ITEM 9. SECTION 96 MODIFICATION APPLICATION: 57 ASHMORE STREET AND 165-175 MITCHELL ROAD ERSKINEVILLE**FILE NO:** D/2015/966/A**DEVELOPMENT APPLICATION NO:** D/2015/966/A**SUMMARY****Date of Submission:** 25 May 2016

Proposal Summary: This Section 96(2) application seeks consent to modify the Concept Approval for a mixed use precinct including residential, commercial and recreation uses, including building envelopes for nine (9) development blocks ranging in height between two (2) and eight (8) storeys and concept design for public domain works including new streets, a 7,446m² park, and new trunk drainage.

The proposed amendments principally involve altering the approved building envelopes to accommodate the detailed design DA for Blocks B and C (D/2017/681) resulting from a design excellence competition. Amendments to specific conditions are also proposed.

Figure 20: Axonometric drawing of the detailed design proposed for Blocks B and C within the existing Concept Approval building envelopes, as viewed from an elevated position to the south-east

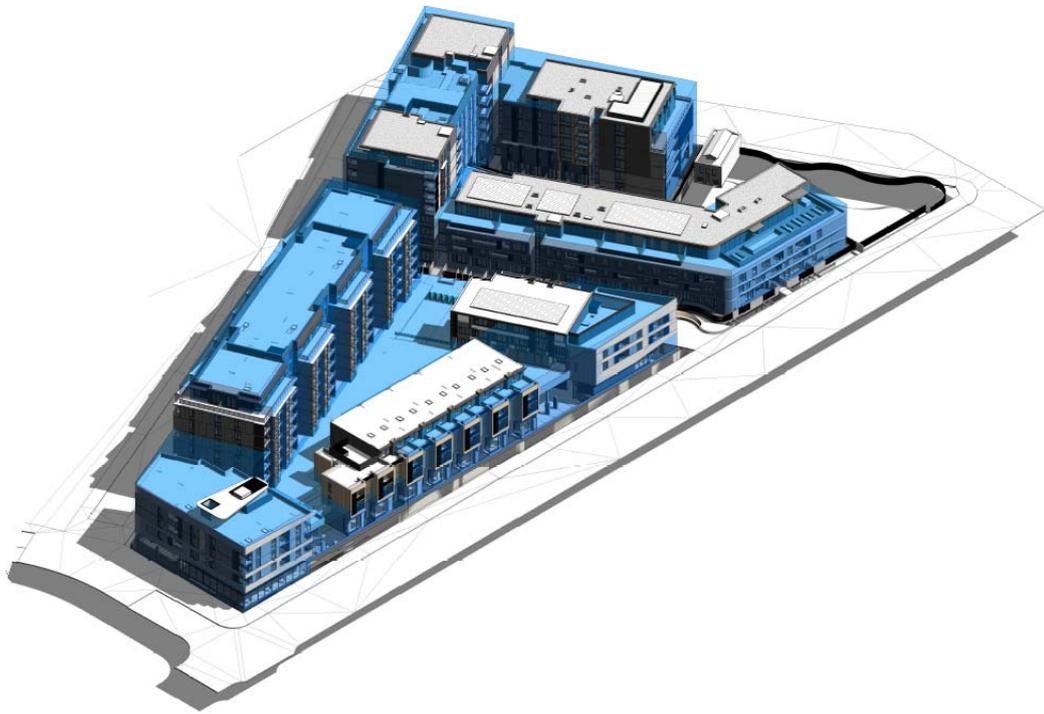
24. Figures 20 and 21 below demonstrate that the detailed design for Blocks B and C results in vertical and lateral protrusions outside the approved building envelopes (shown in blue).

25. In order to remedy these inconsistencies, the scope of the proposed modifications to the building envelopes is as follows:

Figure 22: Axonometric drawing of the detailed design proposed for Blocks B and C within the amended building envelope, as viewed from an elevated position to the south-east

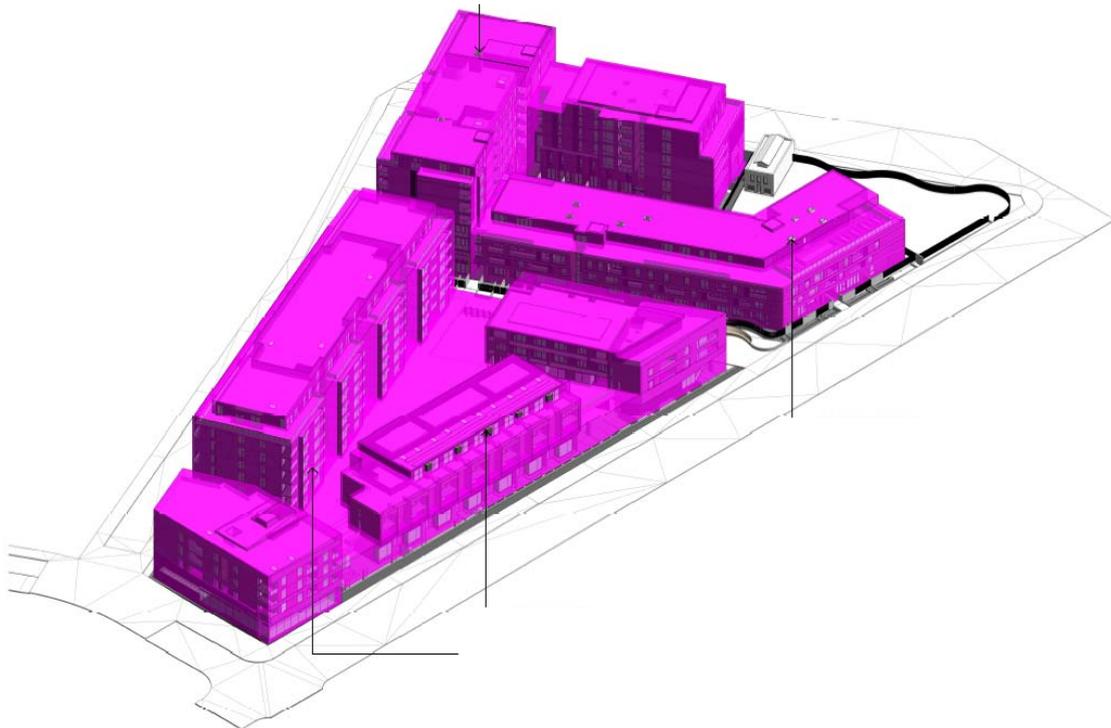
26. Separate to the modifications to Blocks B and C, the amended drawings submitted in October 2017 include an undisclosed change to the Block I building envelope. Specifically, the amended envelope provides a podium level with an area of approximately 276m² in the north western corner of the Block. Refer to the discussion of Block I under the heading issues.
27. The amended building envelopes for Blocks B and C accommodate the detailed design in its entirety (refer to Figures 22 and 23 below).

Figure 24: Axonometric drawing illustrating the existing Concept Approval building envelopes for Blocks B and C.

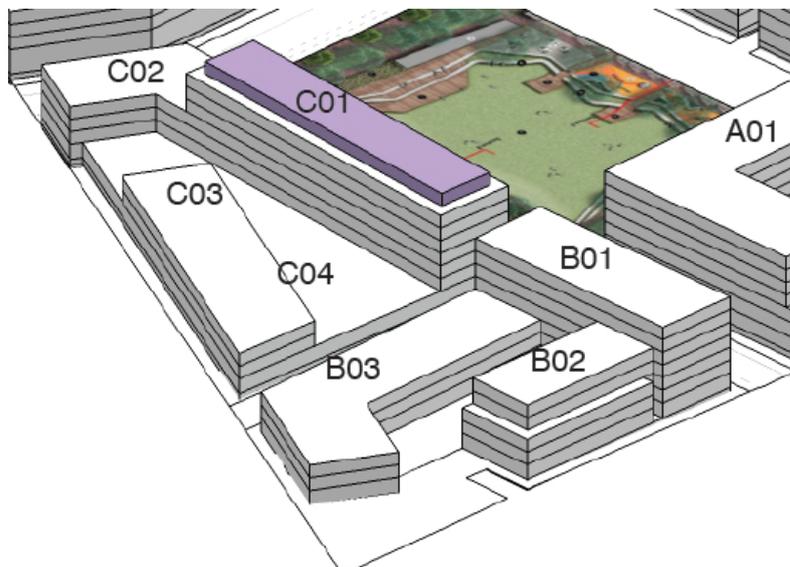
28. Figure 24 illustrates the currently approved building envelopes for Blocks B and C, and Figure 25 illustrates them as proposed to be amended, with key changes to the height in storeys and street wall heights highlighted in blue.

Figure 26: 9am mid-winter shadow analysis. The blue line is the existing Concept Approval shadow, the yellow line is the proposed amended building envelope shadow, and the actual shadows are those cast by the detailed design DA as currently proposed.

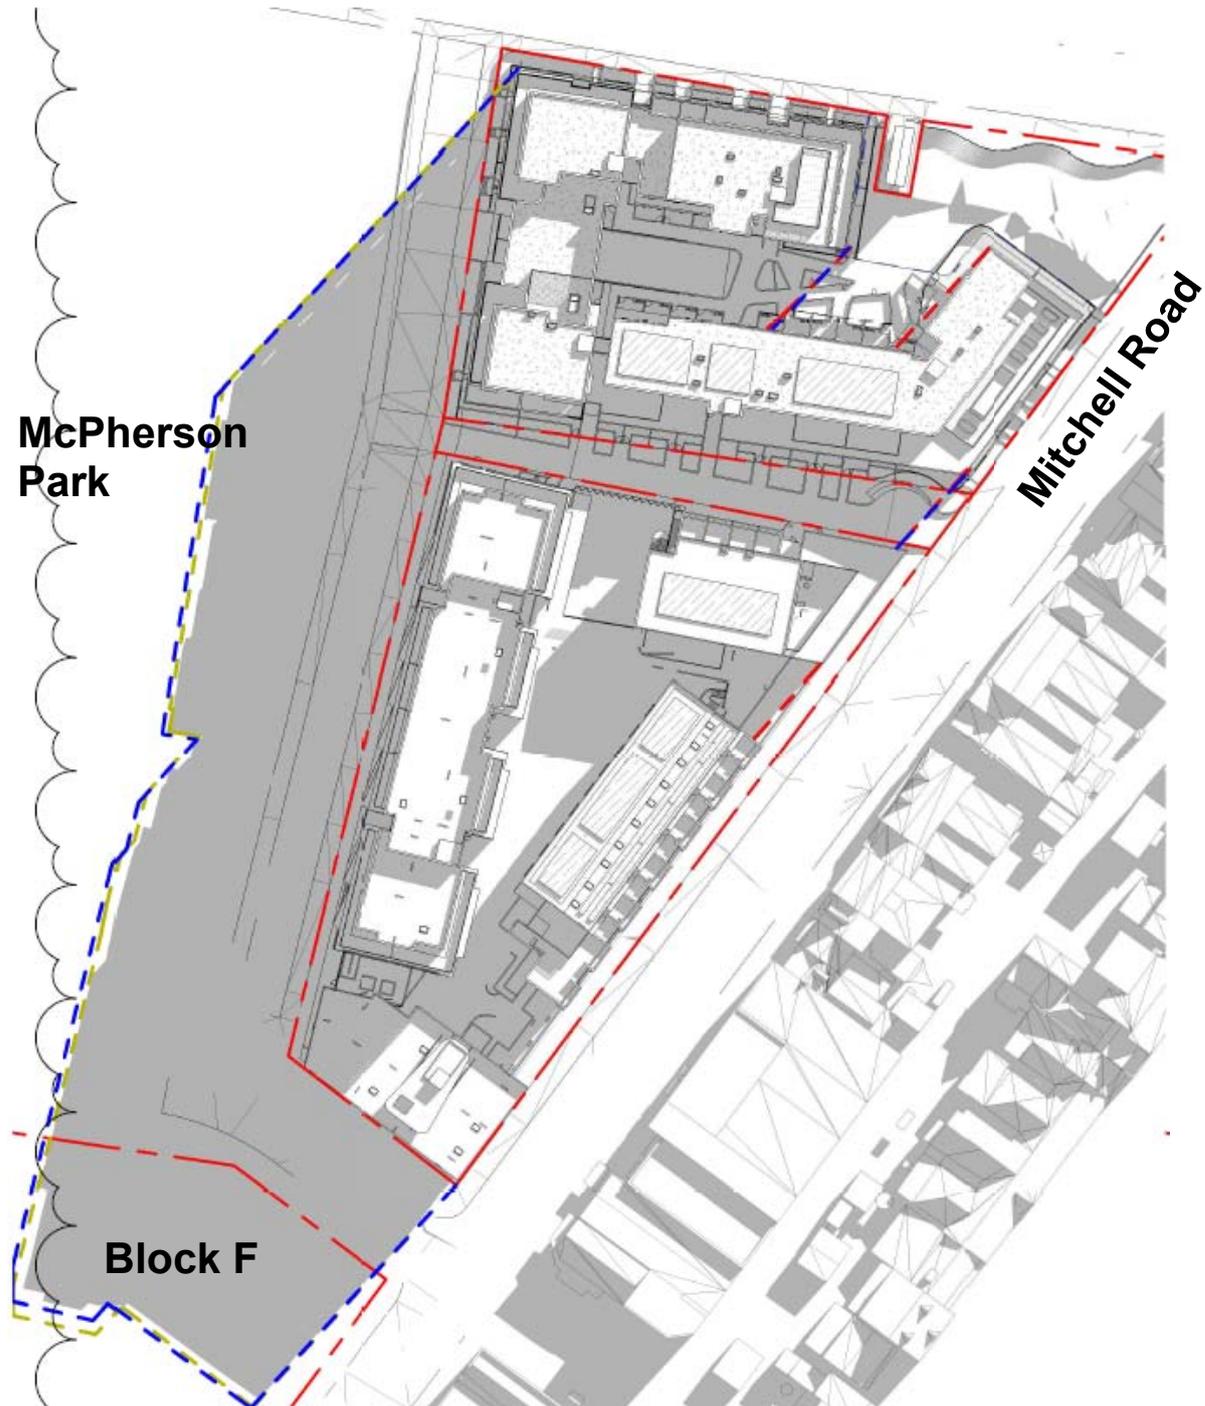
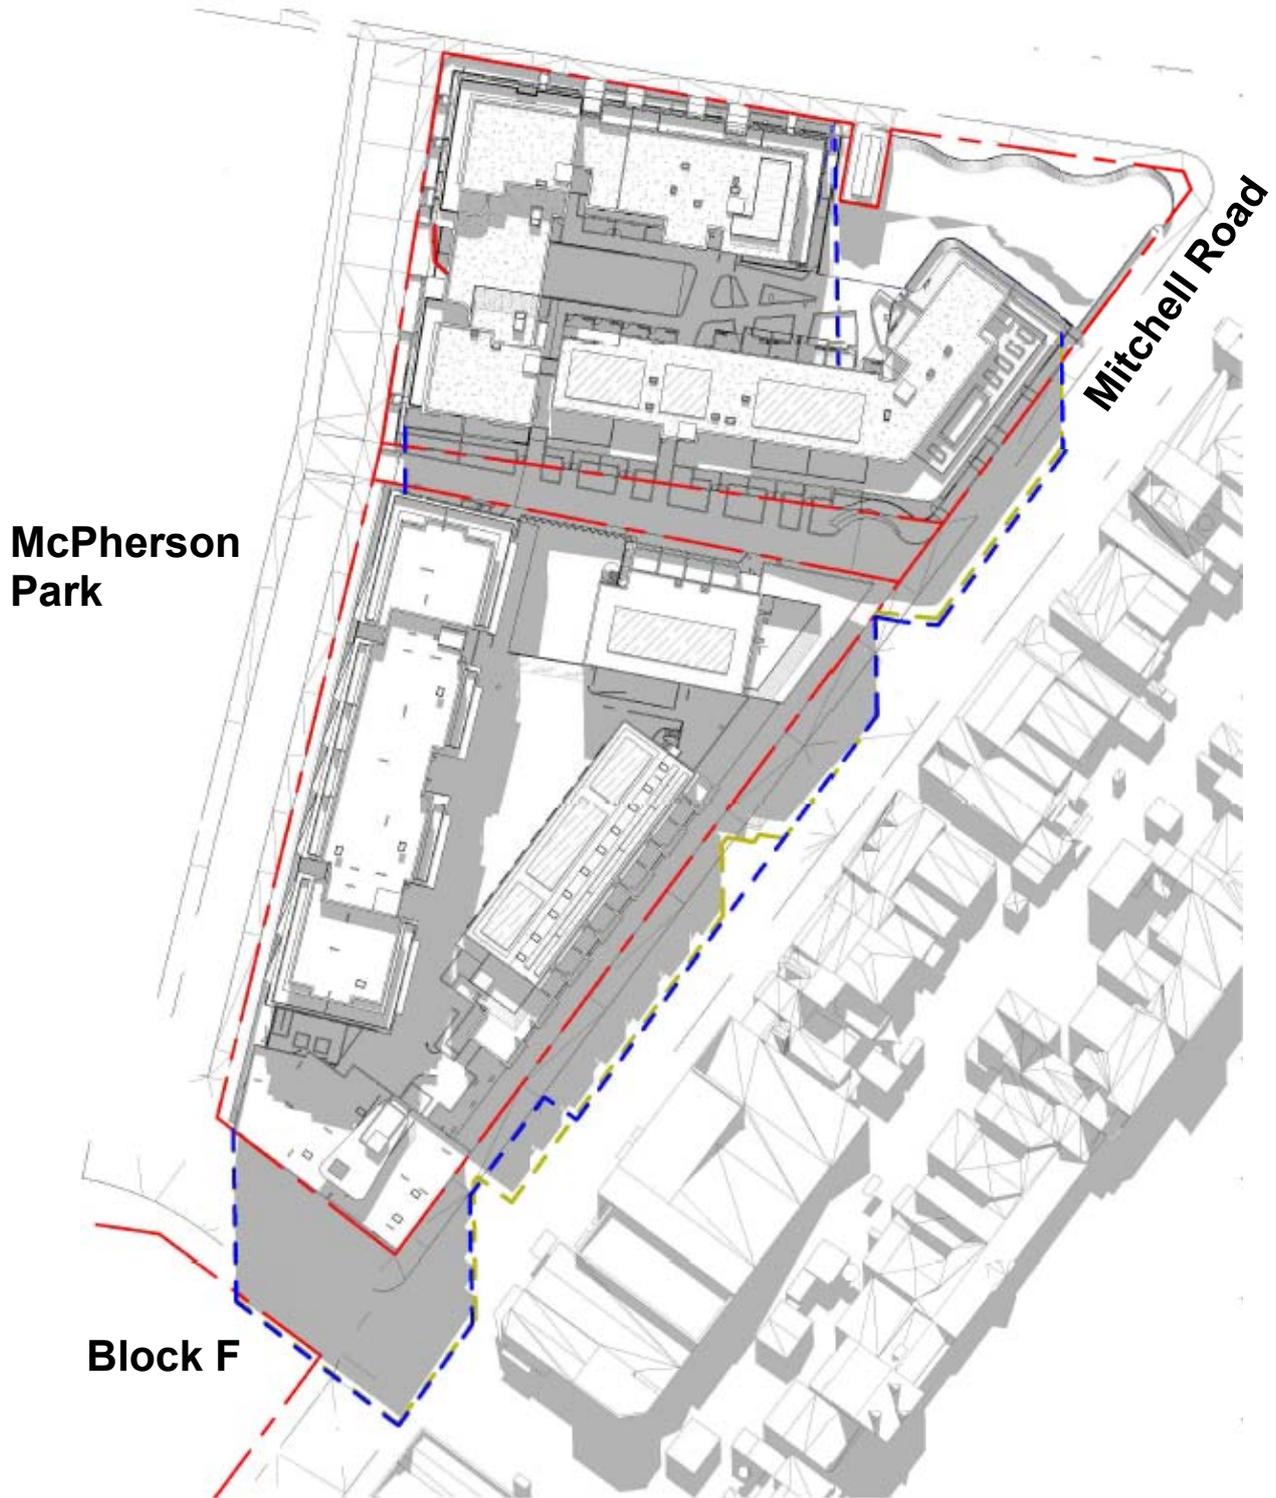
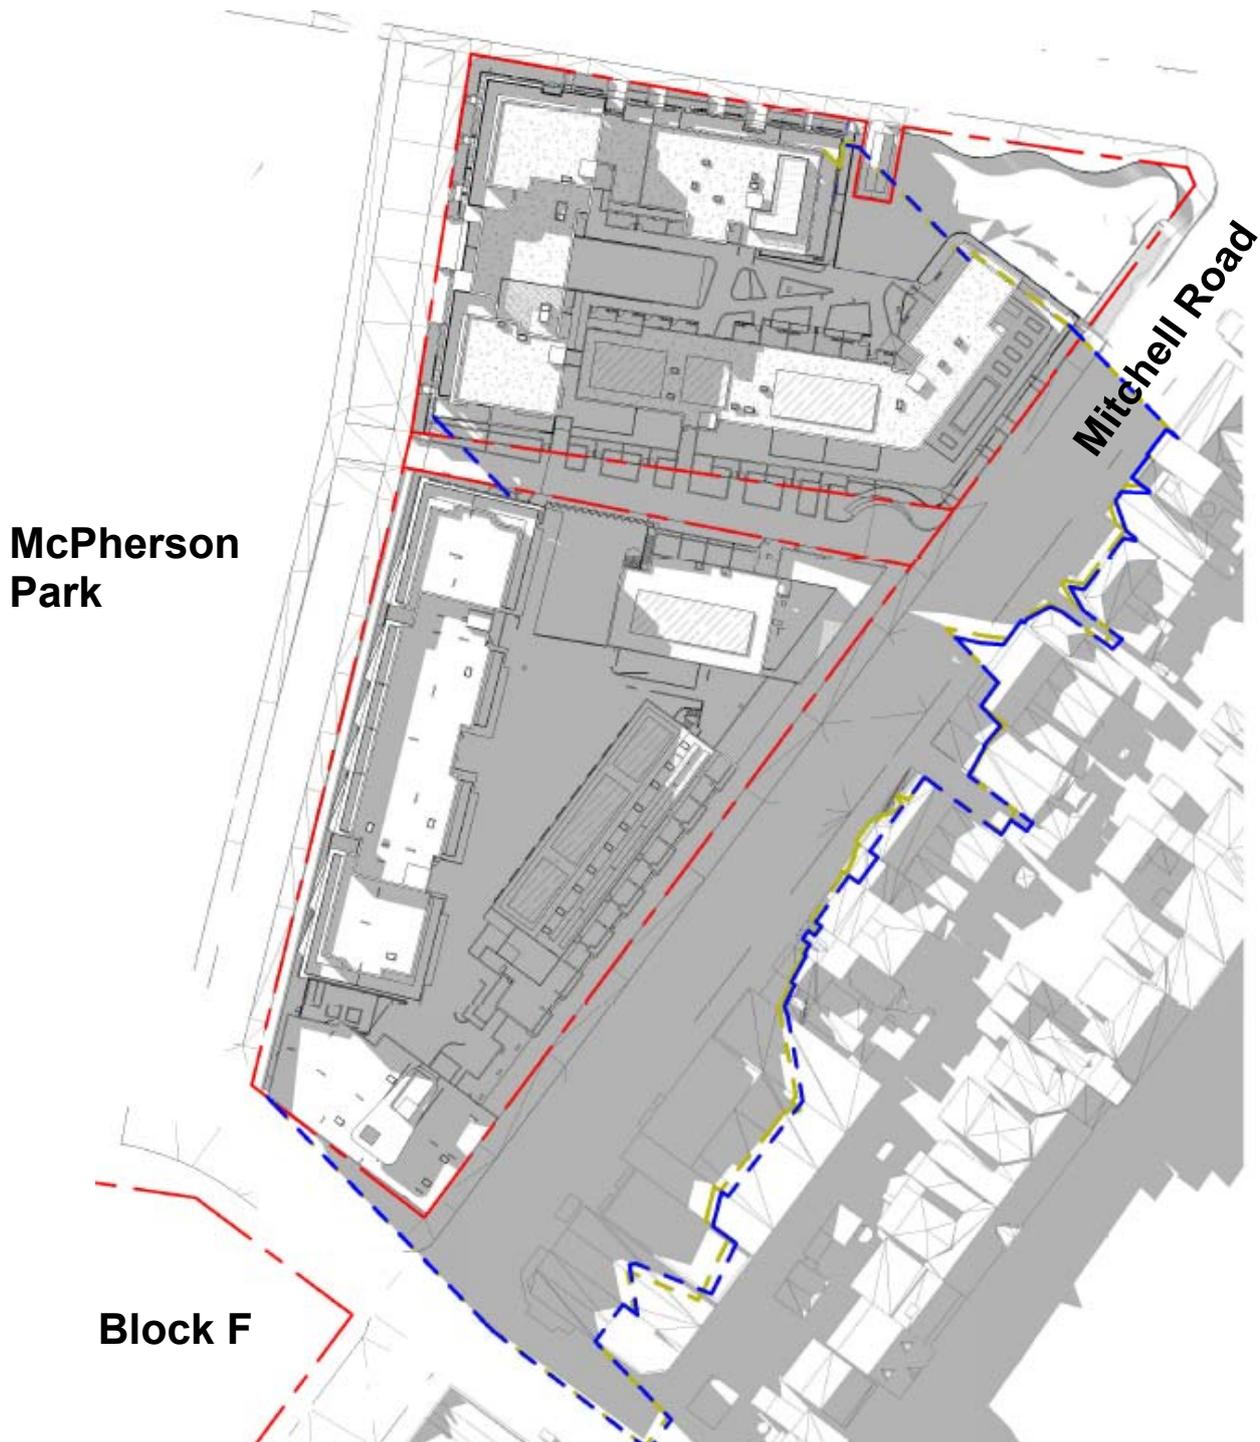
29. Updated shadow analysis has been submitted, which demonstrates that the amended building envelopes do not result in unacceptable overshadowing to the surrounding locality. More specifically, and as illustrated in Figures 26 to 28 below, the amendments result in no additional overshadowing to the future McPherson Park, a similar level of overshadowing to future Block F on the opposite side of Macdonald Street, and no increase in overshadowing to properties on the opposite side of Mitchell Road due to the separation of Building B03 into two sections.

30. Accordingly, the amended envelopes result in no net increase in overshadowing when compared to the approved envelopes.

Figure 30: Approved Block B building envelope shown in relation to the SLEP 2012 height planes

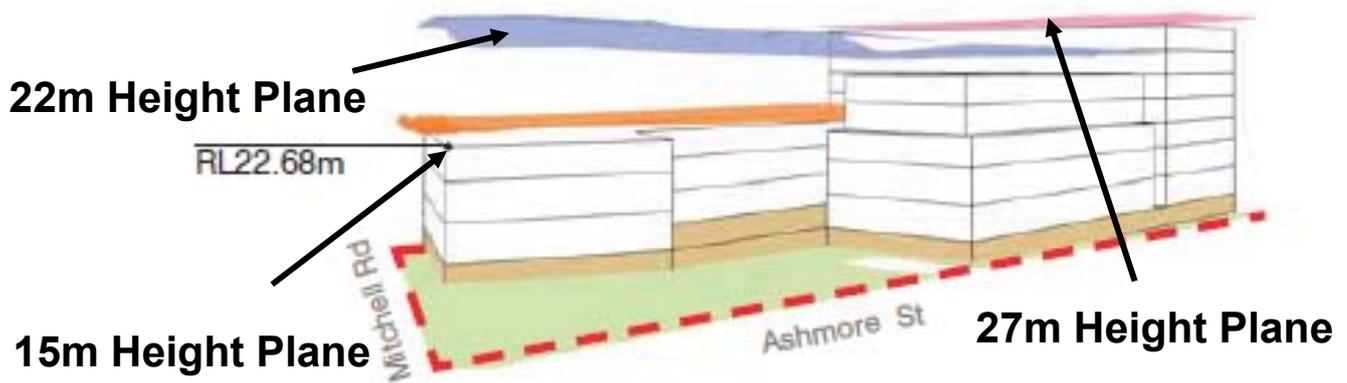
32. The approved building envelopes for Blocks B and C comply with the SLEP 2012 height of Buildings development standard, with the exception of Building C01. Level 8 of Building C01 was approved to a maximum height of 29.84m within the 27m height plane. This resulted in a 2.84m non-compliance, and a variance to the 27 height of buildings development standard of 10.5%. The approved building envelopes, and where they sit within the SLEP 2012 height planes, are illustrated in Figures 30 and 31 below.

Figure 32: 3D drawings illustrating the building envelopes, as proposed to be amended, within the SLEP 2012 maximum height planes.

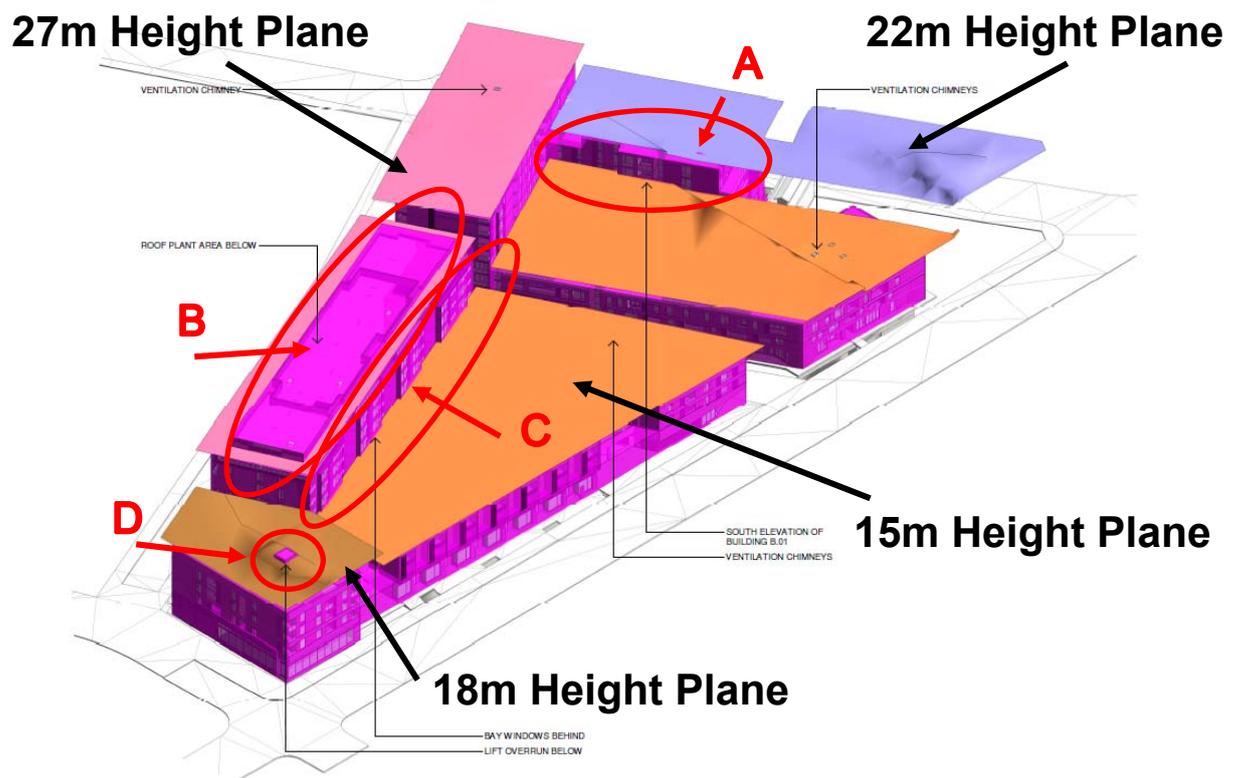
33. The amended building envelopes for Blocks B and C result in additional non-compliances with the SLEP 2012 height of buildings development standards, as illustrated in Figure 32 below.

(a) **Southern face of Building B01 (annotated A above):**

The proposed height of this building is 21.44m. This complies with the 22m maximum height plane within which it is principally located, however a small part of the southern face of the building protrudes in to the adjoining 15 height plane. This results in a non-compliance of 6.44m above the 15m height plane, and a variance to the development standard of 42.9%. 7.86m² of GFA is accommodated on each floor within the non-compliant part of the building.

(b) **Level 8 of Building C01 (annotated B above):**

Building C01 was approved to a maximum height of 29.84m within the 27m height plane (10.5%). The non-complaint floorplate was capable of accommodating 825m² of Gross Floor Area (GFA). Under this proposal, the proposed height is reduced to 29.4m, reducing the non-compliance to 2.4m (8.9%), however the floor plate is widened by approximately 1.05m from 14.5m to 15.55m, resulting in 1,033m² of GFA being accommodated above the 27m height plane.

(c) **Eastern face of Building C01 (annotated C above):**

The articulated facade of this building results in minor lateral protrusions into the 15m height plane on the eastern face of the building. This results in a non-compliance of 9.31m above the 15m height plane, and a variance to the development standard of 62.1%. 16.26m² of GFA is accommodated on each floor within the non-compliant part of the building.

(d) **Lift overrun of Building C02 (annotated D above):**

A communal rooftop is proposed to be provided on this building as part of the separate detailed design DA for Blocks B and C. In order to provide equitable access, the lift overrun protrudes above the 18m height plane to a maximum height of 18.7m. This results in a non-compliance of 0.7m and a variance to the development standard of 3.9%. No GFA is contained within the non-compliant part of the building.

- (iv) The non-compliance arising on Building B01 (annotated A in Figure 32) facilitates an improved landscaped setback to Ashmore Street. This is achieved by pushing the building further south, into the site, resulting in the non-compliance. While the proposed variance is technically large (42.9%), in reality it is only a very small part of the building that is protruding into the adjoining height plane. While consideration could be given to deleting the non-compliant part of the building, this would have significant repercussions in terms of the internal layout of the floorplate. In the absence of any impacts arising from the non-compliance, such a request would be unreasonable. Accordingly, on balance, the proposal is considered superior to a compliant scheme, which would be less capable of simultaneously providing an acceptable setback and a rational floorplate.

- (v) The non-compliance on Level 8 of Building C01 (annotated B in Figure 32) was approved at Stage 1, albeit in a slightly different form. The proposed modification reduces the overall height of the non-compliance above the 27m height plane from 29.84m (10.5%) to 29.4m (8.9%), however the width of the floor plate is widened by 1.05m. The overall impact of this modification is minor, as evidenced by the view loss and the overshadowing analysis provided earlier in this report. While consideration could be given to requiring the width of the floorplate to be maintained at 14.5m, rather than 15.55m, this would have significant repercussions in terms of the internal floor plate layout. In the absence of any impacts arising from the non-compliance, and given the overall height of the building is decreasing, such a request would be unreasonable.

- (vi) The non-compliance on the eastern face of Building C01 (annotated C in Figure 32) facilitates improved solar access to apartments by providing a 'pop-out' window with glazing orientated to the north, as illustrated in Figure 35 below. If the facade was flattened in order to contain the building entirely within the 27m height plane, the affected apartments would no longer achieve two hours solar access at mid-winter, and overall solar access would be non-compliant with the minimum requirements of the ADG. While the proposed variance is technically large (62.1%), in reality it is only a very small part of the building that is protruding into the adjoining height plane. The proposed non-compliance is considered to result in an improved outcome for the site, and therefore a request to flatten the facade to contain it within the 27m height plane would be unreasonable.

- (vii) The non-compliance on the roof of Building C02 (annotated D in Figure 32) is to accommodate equitable access to the communal rooftop. The proposal results in no impacts to view corridors, does not contribute to overshadowing, and will not be visible from the public domain. If the proposal was amended to comply, equitable access to the communal rooftop may not be achieved. Accordingly, the proposed non-compliance is considered to result in an improved outcome for the site over a compliant scheme and therefore a request for strict compliance with the height standard would prevent the provision of equitable access to the rooftop and would be unreasonable.

36. In light of the above, despite the proposed variations to the height of buildings development standards, the proposal is consistent with the zone objectives and the objectives of the development standards have been achieved. Insisting on strict compliance with the height of buildings development standard is unreasonable and unnecessary in the circumstances of the case, and there are sufficient environmental planning grounds to vary the standard. Accordingly, the proposed variations are supported and are recommended for approval.
